**INTERA ENGINEERING LTD.**

Ref: 04-233-1

**Re: Hydrogeologic Review Report – Proposed Lowndes Dolostone Quarry, East Flamborough, City of Hamilton**

Figure 1  
04-233

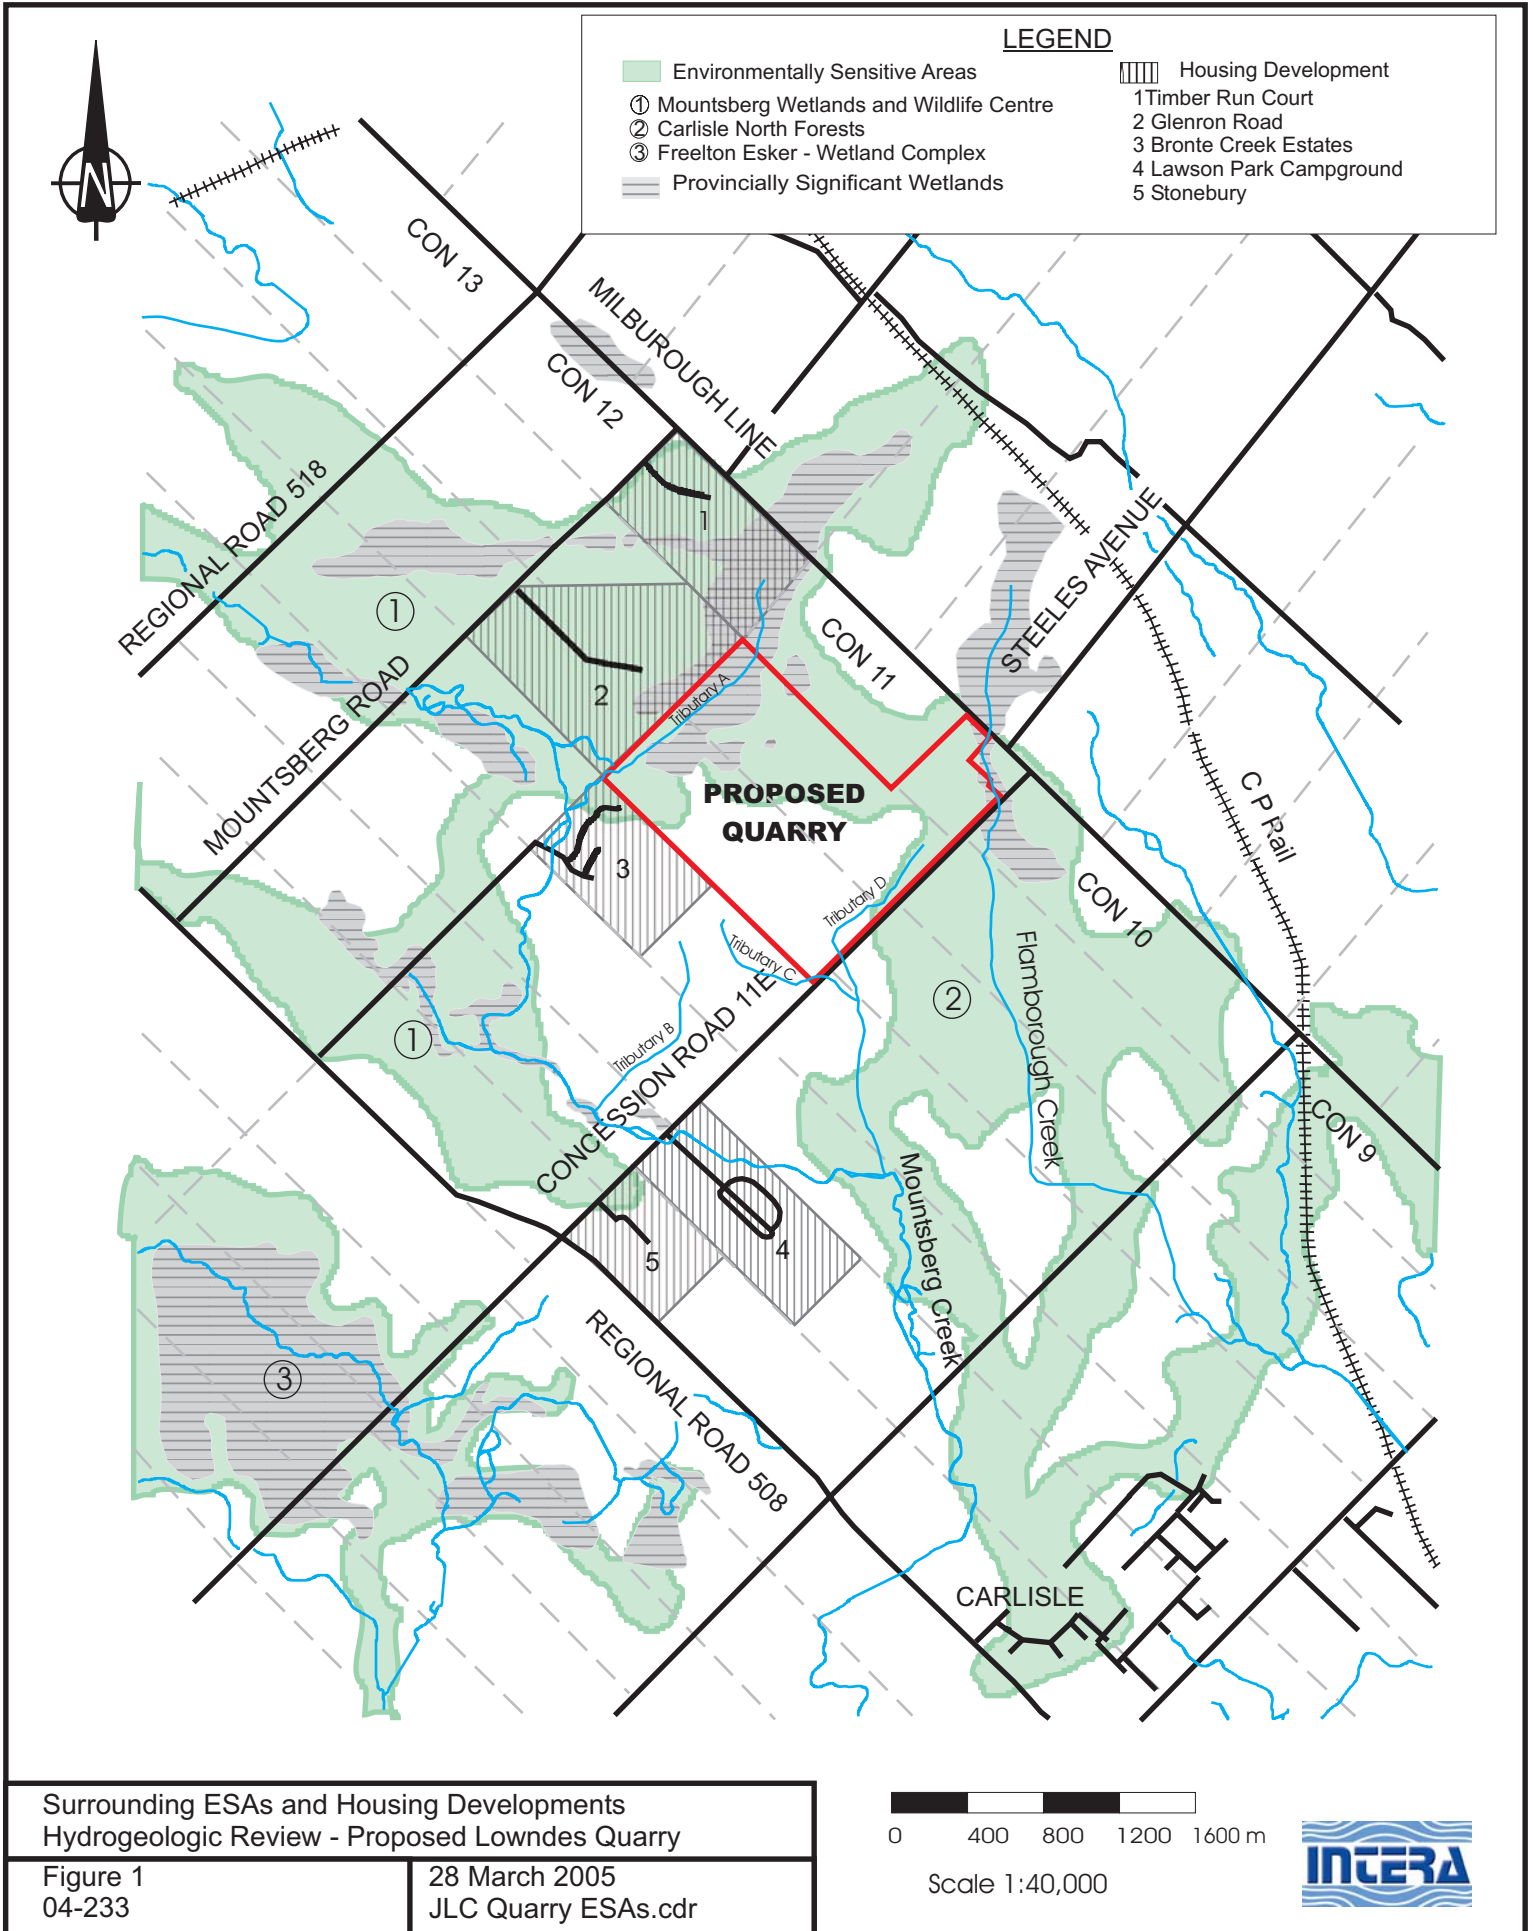
In addition to individual residences, several subdivision developments are situated adjacent or proximate to the proposed Quarry. According to the 2004 *City of Hamilton Information Report*, there are several residential developments within 500 m of the Quarry, including an estate residential development on Glenron Road (13 lots), Timberun Court (19 lots), and a rural estate residential condominium (Bronte Creek Estates – Sierra Lane, 76 residential units draft approved with 31 units currently registered). A seasonal campground-trailer park (Lawson Park Campground - 185 sites) and housing development (Stonebury – about 14 houses) are also located about 1000 m and 1200 m, respectively, southwest of the proposed Quarry. Figure 1, appended to this letter, shows the location of these residential developments relative to the proposed Quarry site.

There are also several streams and creeks within 250 m of the proposed Quarry excavation (see Figure 1). The 2004 *Preliminary Level 2 Natural Environment Report* (Section 4.1.3 and Figure 7) indicates that Tributary A, Tributary D and Flamborough Creek are all fish habitat. Tributaries B and C are not known to support fish habitat but provide baseflow to Mountsberg Creek located further west of the site. Similar to the Wetlands, the setting of these creeks suggests that they may be in direct hydraulic connection to the shallow groundwater system and hence would be susceptible to Quarry dewatering effects.

Figure 2  
04-233

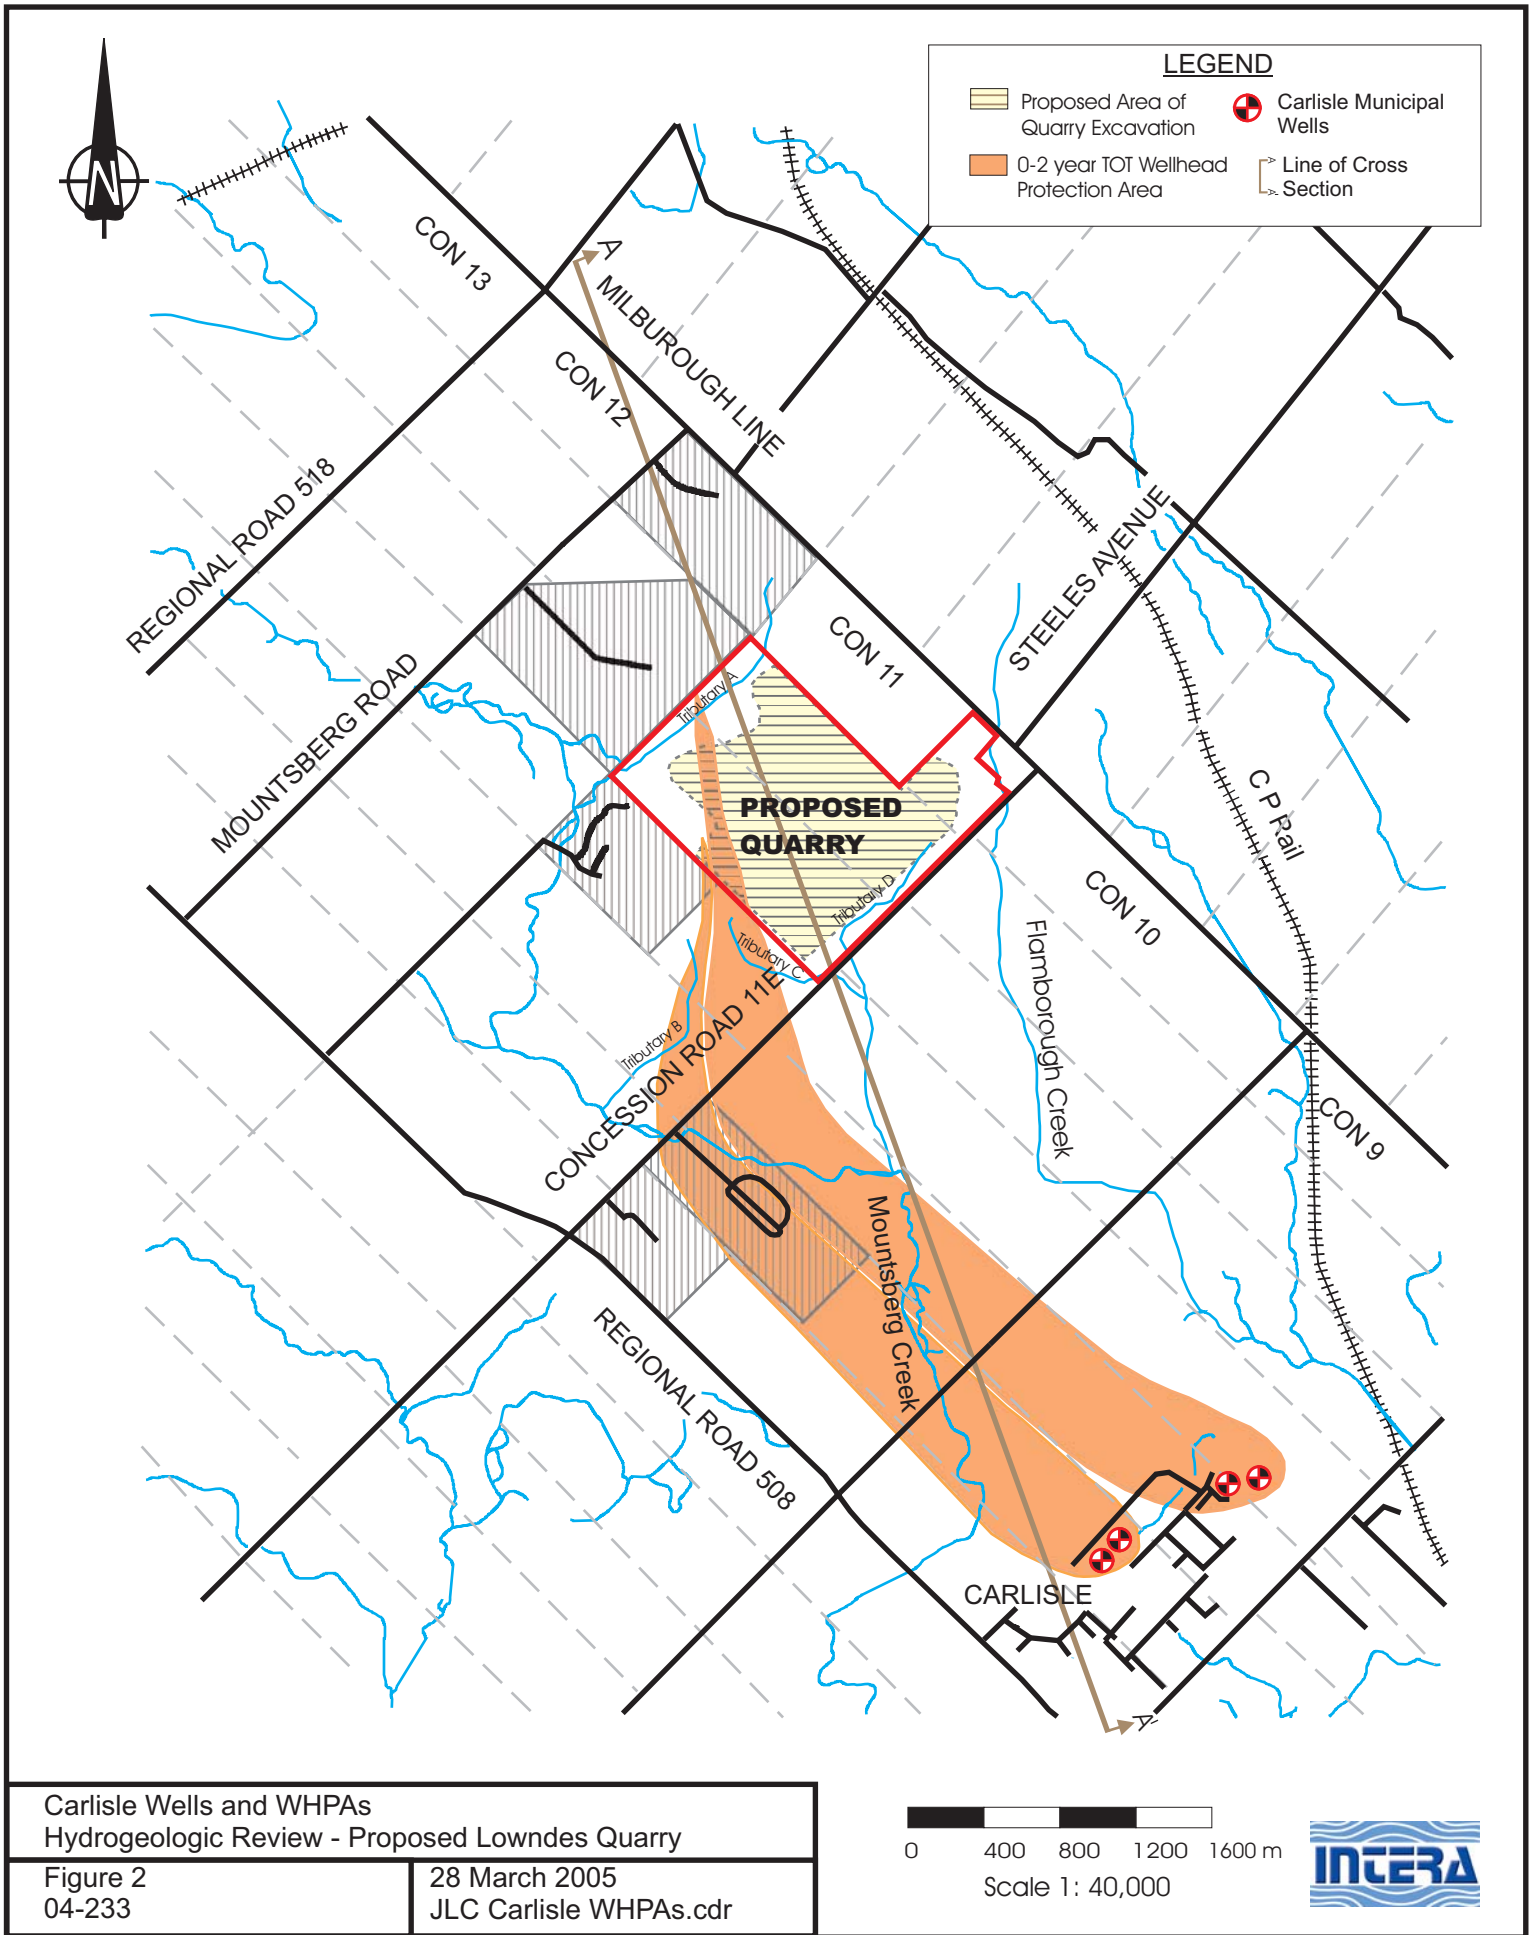
The proposed Quarry is also located in the groundwater recharge area and wellhead protection area (WHPA) for the Carlisle municipal water supply wells. Figure 2 shows the location of the Carlisle municipal water supply wells and the 0 to 2 year time-of-travel WHPA for these wells relative to the proposed Quarry. Figure 3 schematically illustrates a hydrogeologic cross section constructed through the proposed Quarry, showing the Amabel formation dolostone, typical depths of private and communal wells and the location of the Carlisle municipal wells. The line of cross section for Figure 3 is given on Figure 2.

Figure 5.6 of the 2004 *Presentation, Groundwater Resources Characterization and Wellhead Protection Partnership Study* and Figure 40 of the 2004 *Planning Report* show that the proposed Quarry is located within and beside the 2 year reverse time-of-travel (TOT) wellhead protection area (WHPA) for the Carlisle municipal water supply wells. Figure 2 of this report shows the outline of the 2 year WHPA and the proposed Quarry.

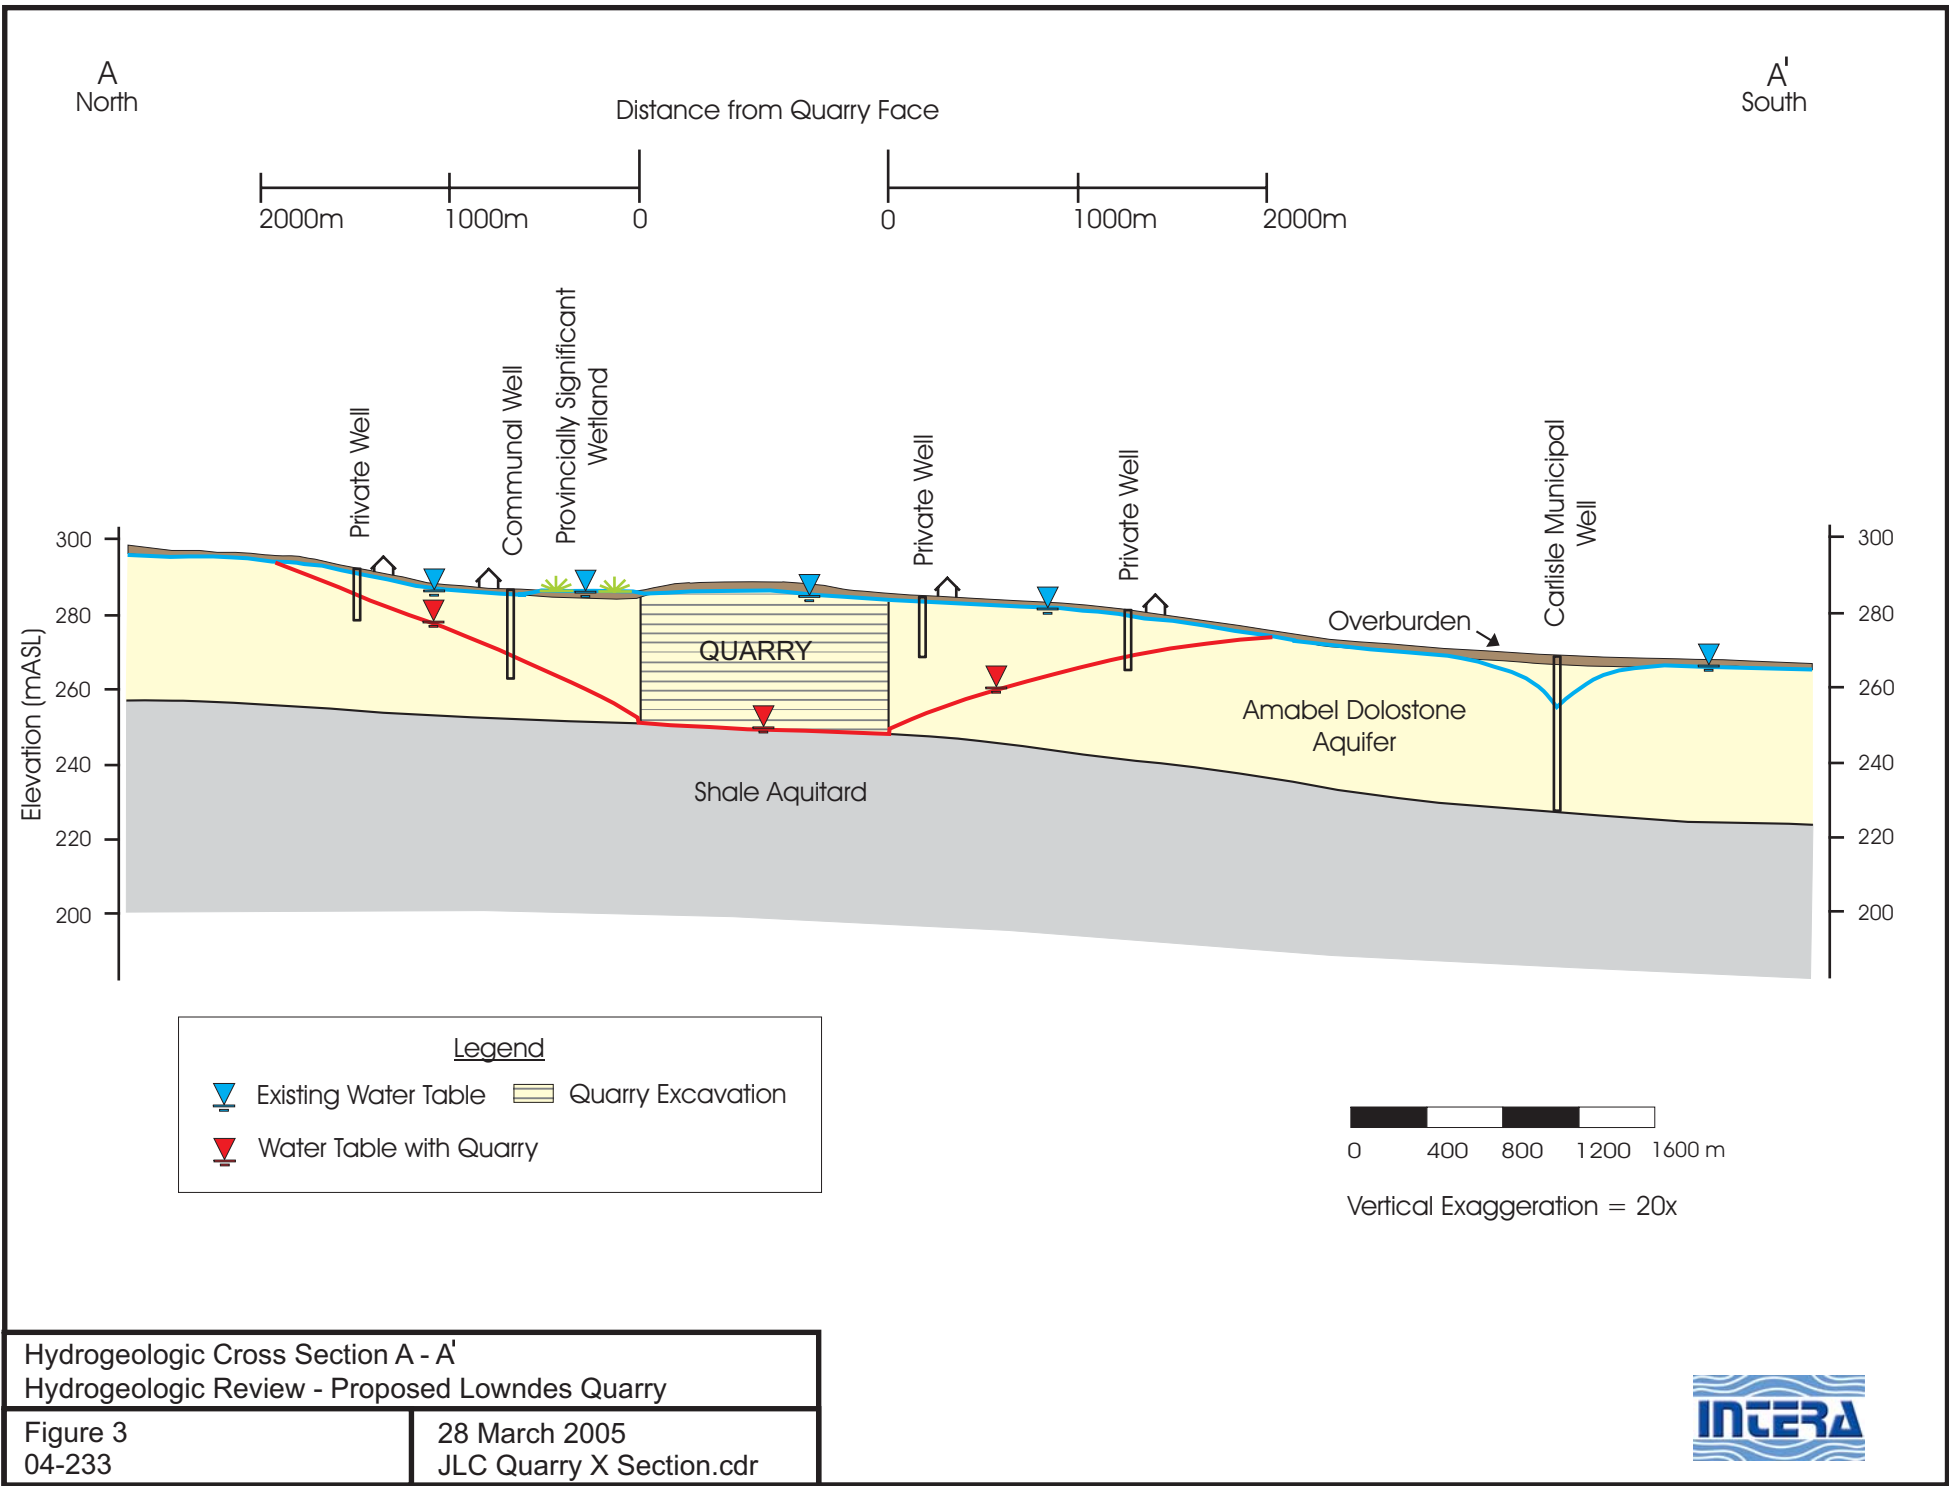
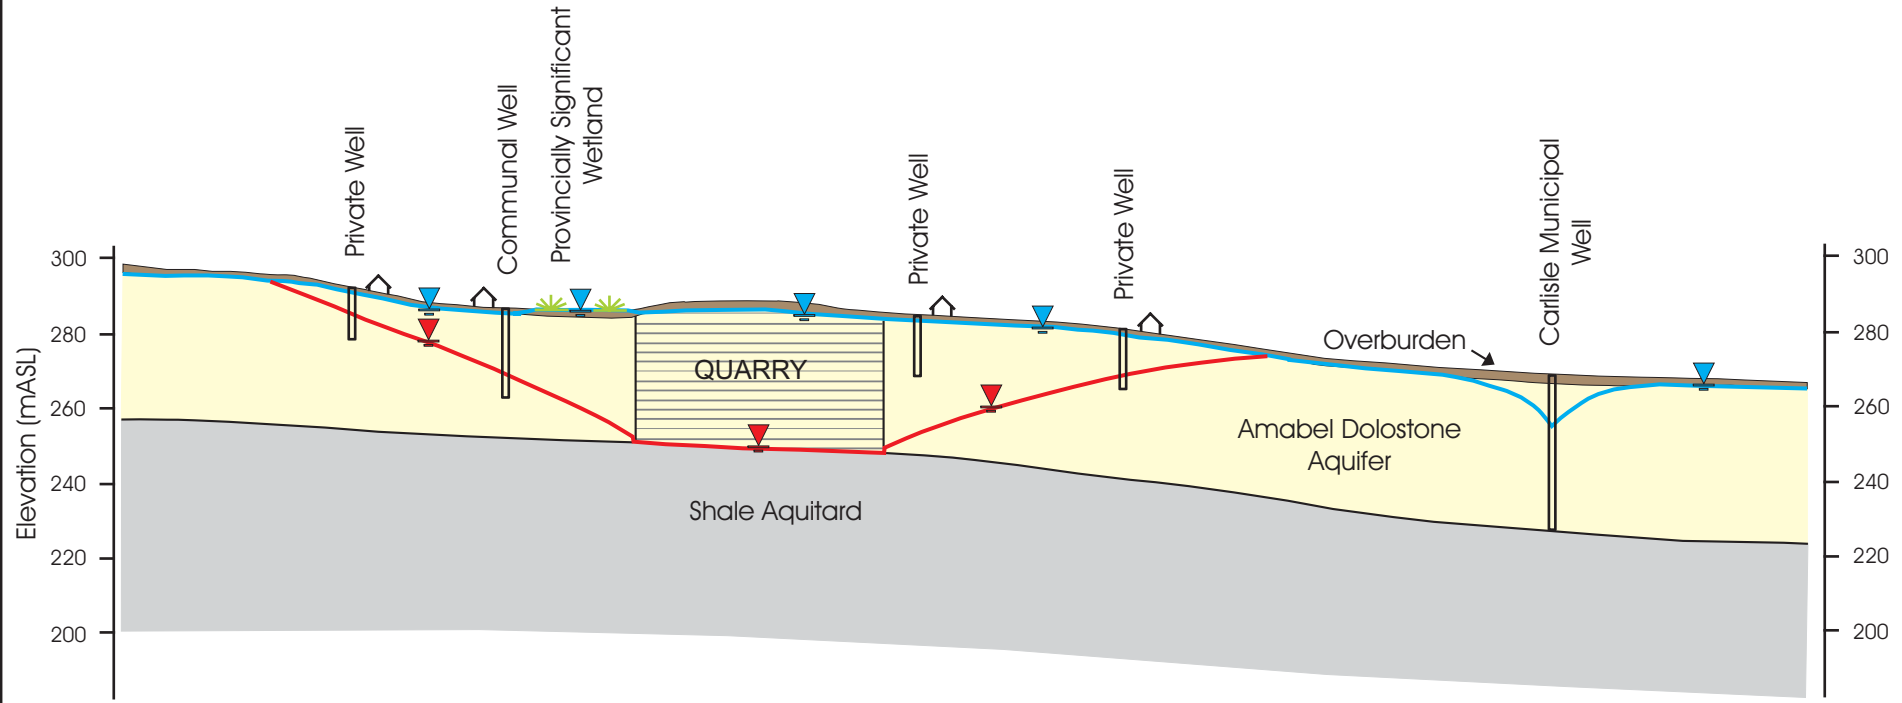
Thus expected drawdowns would range from about 31 m at the Quarry face to about 13 m at a distance of 1000 m from the Quarry face, with essentially negligible drawdowns at distances of about 2000 m from the Quarry face. These expected drawdowns are shown in cross section in Figure 3. These

expected drawdowns are much greater than those presented by the proponent, which are essentially zero at a distance of greater than 600 m.
